Docket Item #7
BAR CASE #2006-0034

ISSUE: Addition and alterations

APPLICANT: Jennifer & Nels Nordquist by Robert Bentley Adams

LOCATION: 408 Duke Street

Figure 1 Proposed rear

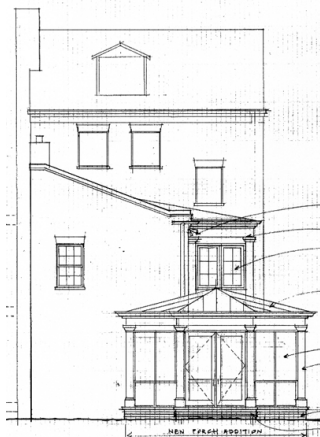
The proposed addition is minimally visible from Duke Street. Because of the brick wall on Duke Street the only section of the new addition that will be visible is the second level. The one story screened porch will not be visible from the public right-of-way.

Based upon these factors, Staff has no objection to the proposed addition to the east side of the flounder.

Figure 2 Proposed side

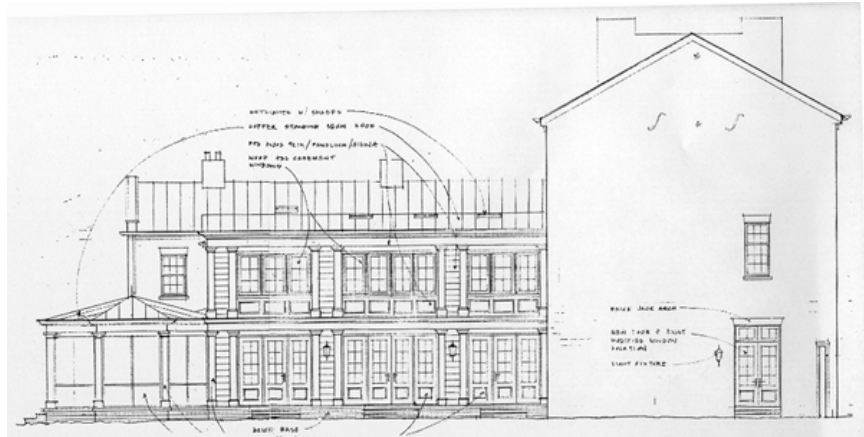
The proposed addition to the east side of the flounder is proposed to be two stories in height and approximately 36' in length and 7'6" in width. On the east side of the first level the addition will have three sets of multi-light wood doors flanked by wood multi-light sidelights on a brick base. The second level will have a similar configuration of three sets of wood casement windows above wood panels. Each of the door or window divisions will be defined by flanking wood Doric pilasters.

At the south end of the first level of the addition will be an octagonal wood screened porch with a standing seam copper roof. The porch will have wood columns and a pair of wood screen doors on the south end above a brick base. The second level of the addition will have a pair of wood casement windows flanked by wood pilasters

The roof of the addition will be standing seam copper and have three skylights. All of the windows are proposed to be true divided light wood.

Figure 3 Proposed front

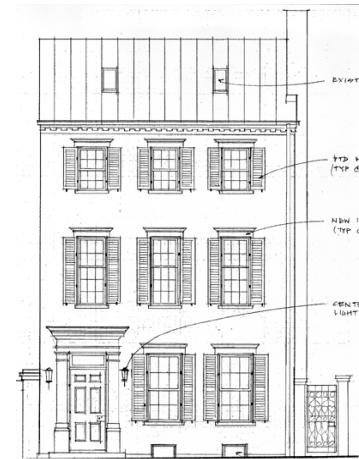
New wood lintels will be added to the existing windows on the front of the house.

A new basement window to infill an existing coal chute is proposed at the front of the house.

Staff has no objections to the proposed alterations of the first floor window to a door, the infill of the coal chute on the front of the house, the new windows lintels nor to the new skylight on the roof of the flounder section. Likewise, Staff has no objection to the pergola which is similar to a number of other pergolas that have been approved by the Board in recent years.
